WATER RIGHT TRANSFER COVER SHEET

Transfer: T-14200

Reference: Transfer Application T-14200

In the Matter of Transfer Application	)	FINAL ORDER DENYING TEMPORARY
T-14200, Lake County	)	CHANGES IN PLACE OF USE AND POINT
	)	OF APPROPRIATION

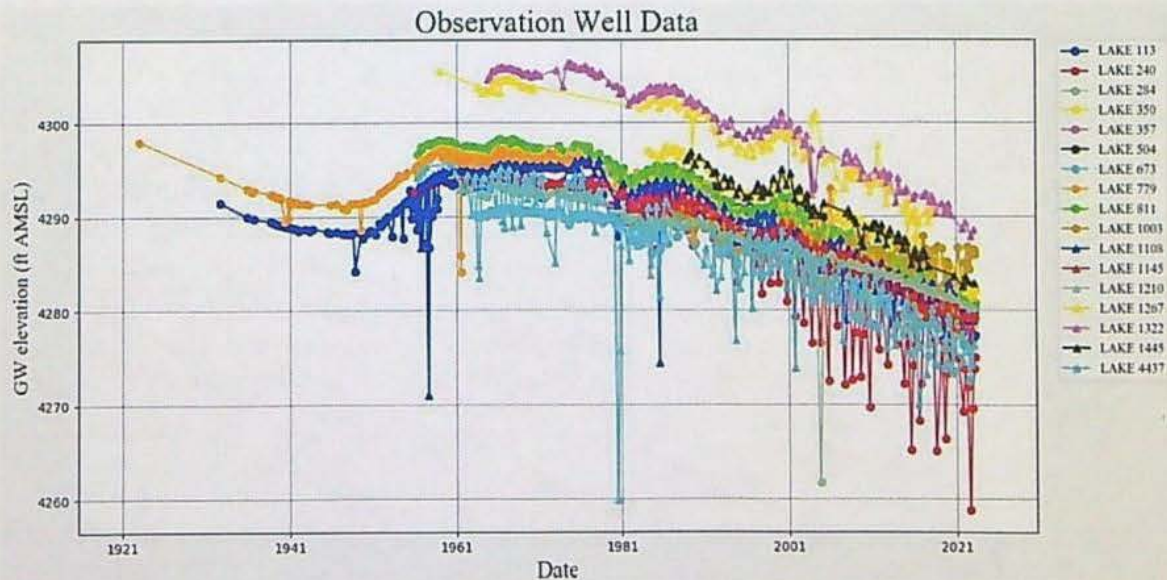
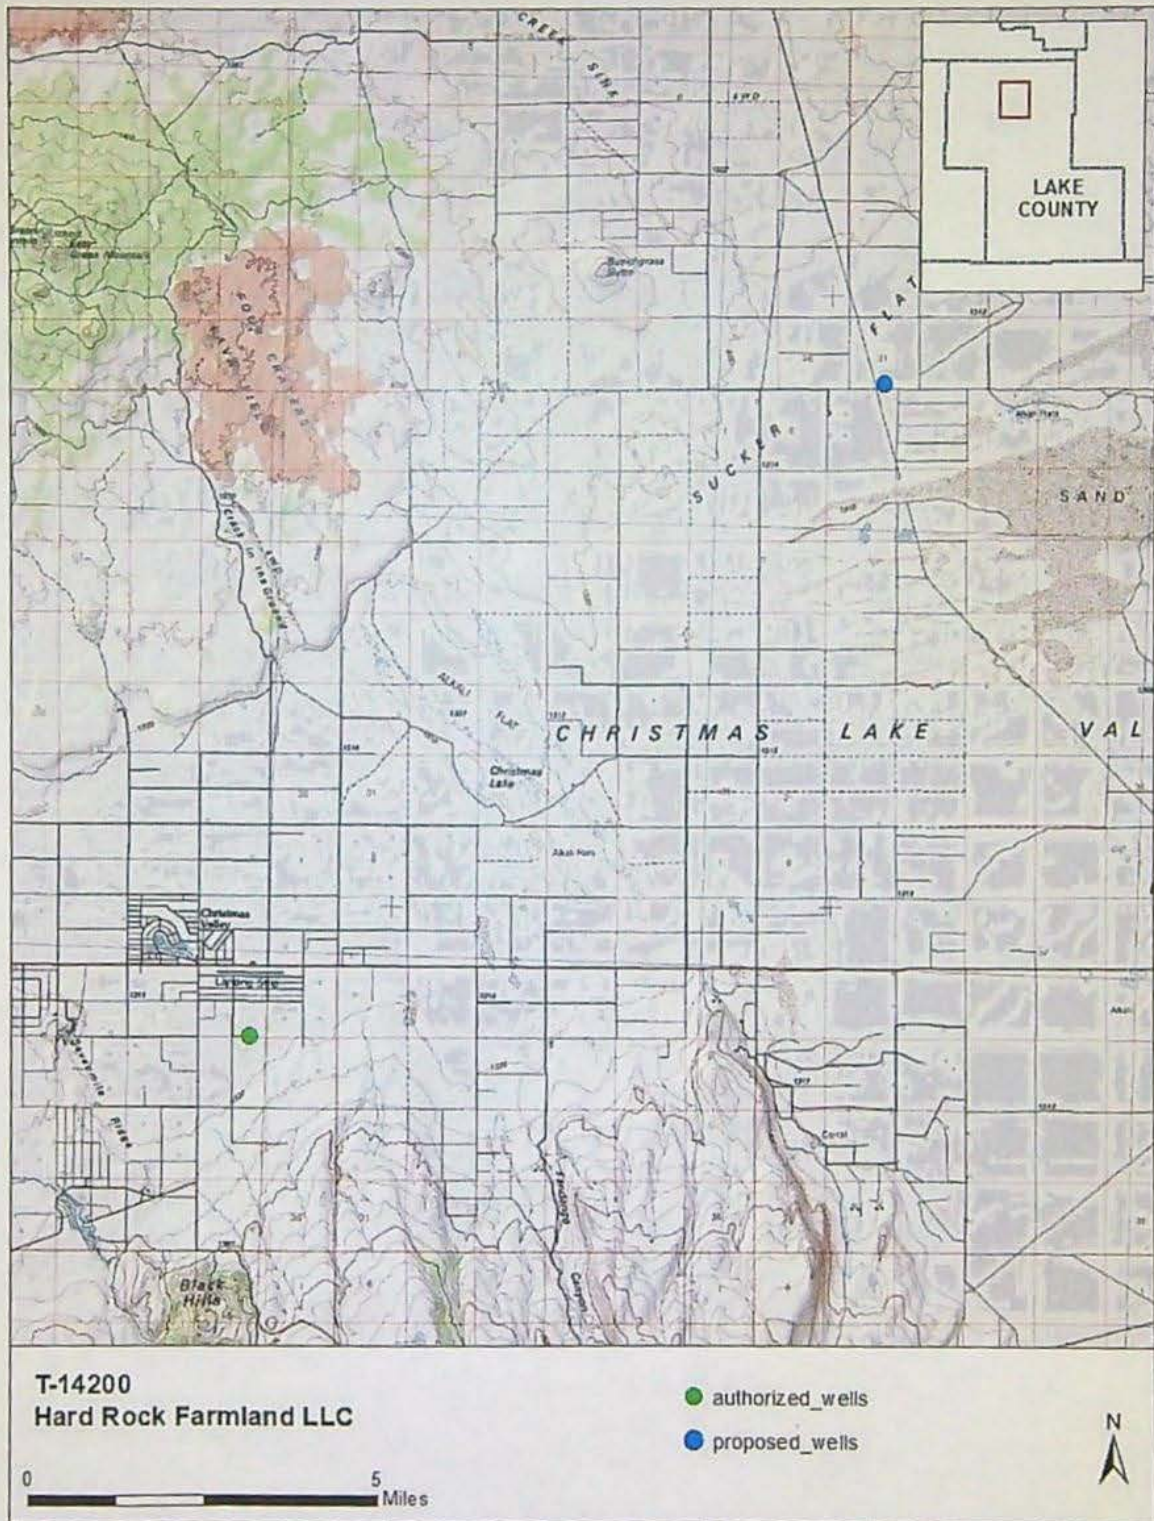
The long-term impact on the groundwater system should be the same. That impact is to continue contributing to the ongoing annual Fort Rock Classified area groundwater level decline. See attached hydrograph.
